PRODUCT CHANGE NOTICE (QR18)

PCN # USB3140 C PCN
20160930

USB3140-30-XXXX-X-C

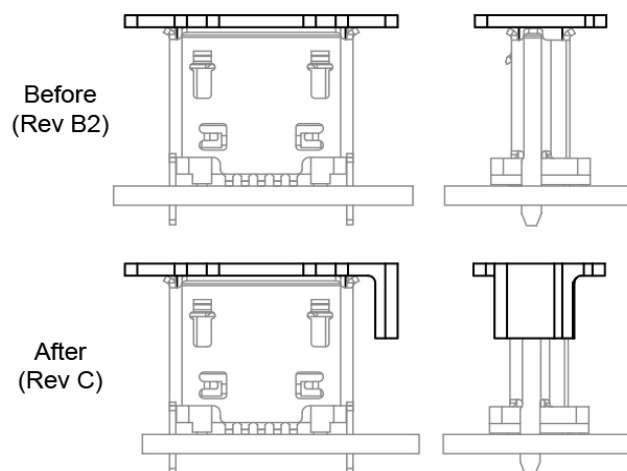
1. Added PCB mount view
2. Re-designed cap

New cap design will restrict the height of components that could potentially be placed on the PCB underneath the cap.
